The following addendum supersedes information contained in the drawings and specifications issued of the project to the extent referenced. This Addendum forms part of the Tender Documents and is subject to all conditions set out in the contract documents

ELECTRICAL ADDENDUM E-02

Project title/Titre du projet
**ESQUIMALT GRAVING DOCK (EGD)
REPLACE MAIN DISTRIBUTION LINE (RMDL)**

**B.C. HYDRO (BCH)
POINT OF DELIVERY (POD)
SWITCHGEAR**

3 SECTION AT STATION 2+02
1003 H & V 1:100

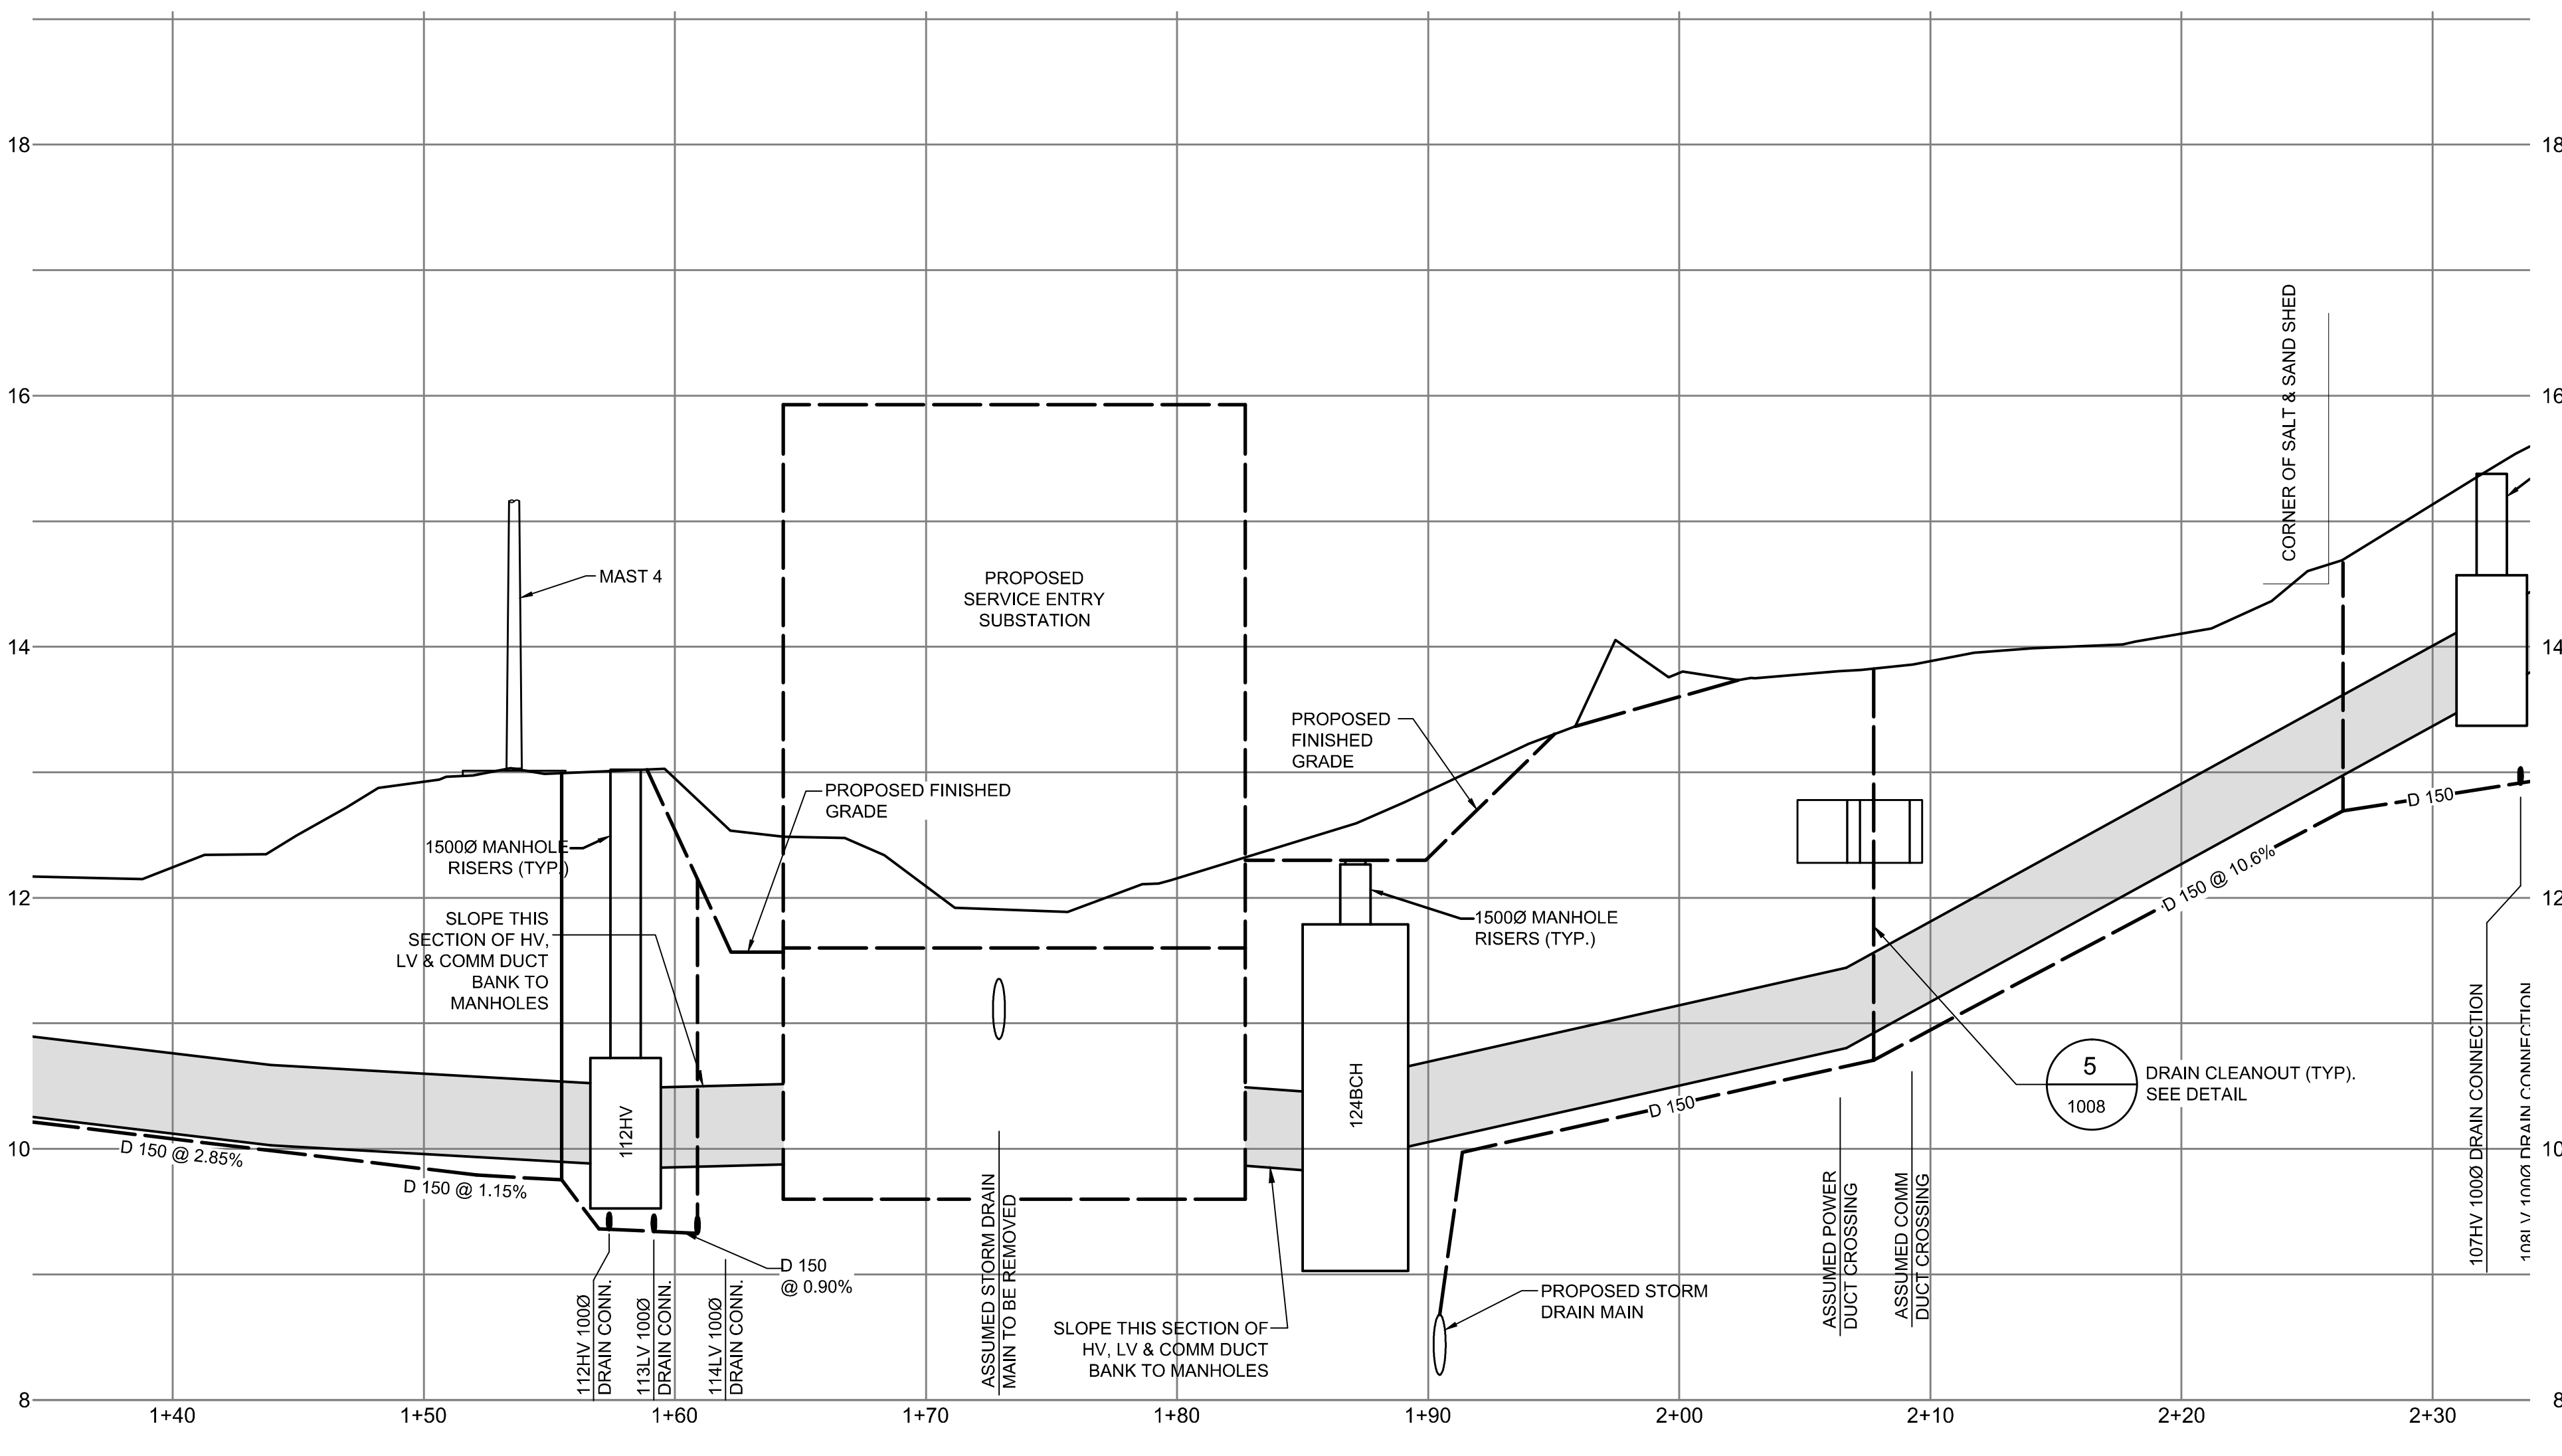
Q: Please issue a site plan showing the location of the SES building in reference to the BCH switch.

A: A basic site plan shall be provided and attached to this addendum. Refer to attached drawings “Service Entrance Substation (SES) & Pump House Substation (PHS)” drawing 1000, 1001, 1002 and 1003.

TYPE A AND B SONOTUBE CONCRETE BASES

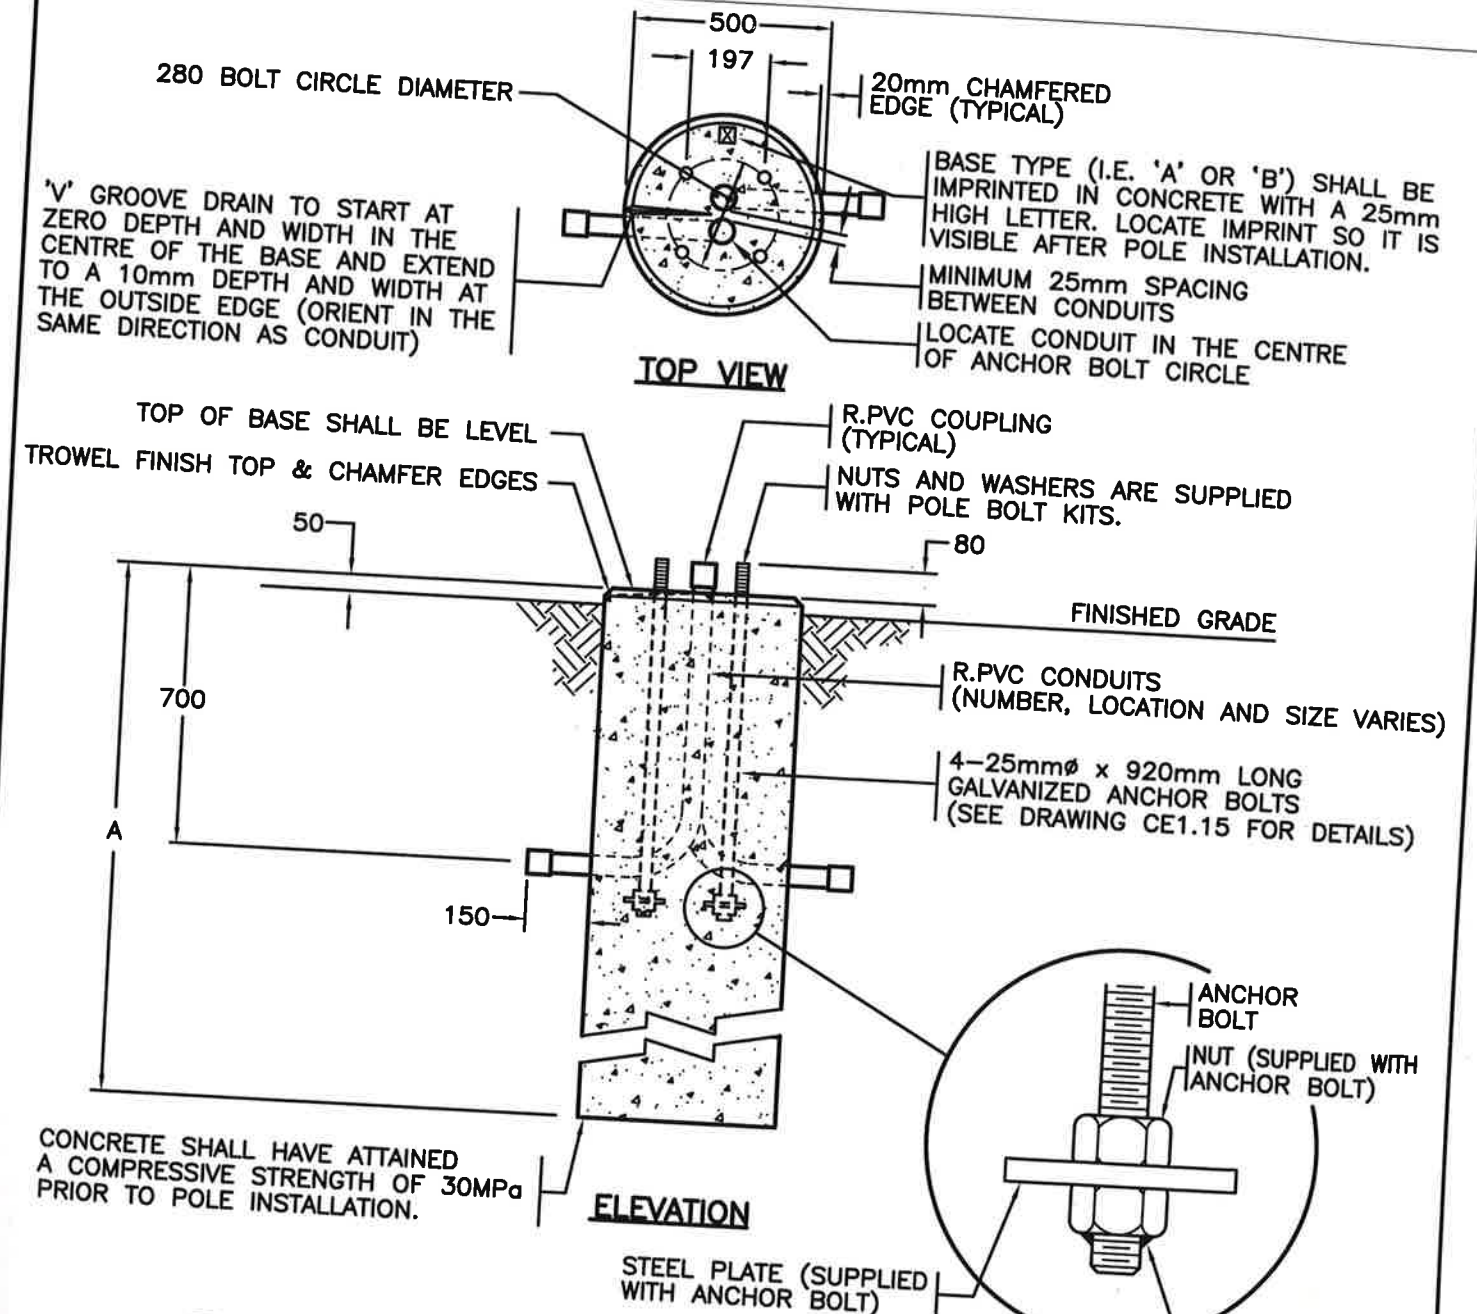
Q: Drawing E03 Keynote 23 & 26 indicate light standards to be used as corner posts for fence. Specification 26 50 00 Section 3.1-4 indicates lighting supported by fenceposts. If Light Standards are required at the corners please provide a specification and base detail.

A: Lighting fixtures and cameras shall be supported by light standards. The light standards shall be used as corner fenceposts. The pole’s height and fixture mounting height is shown on drawing E03. Poles shall be hollow square poles with an powder coat black aluminum finish, with ability to allow for lighting and camera mounting as required, manufactured by Valmont West Coast Engineering or Nova Pole, or approved equivalent. Pole base shall be to MMCD Standard Detail Drawing Type B Sonotube concrete base or approved equivalent, as attached.
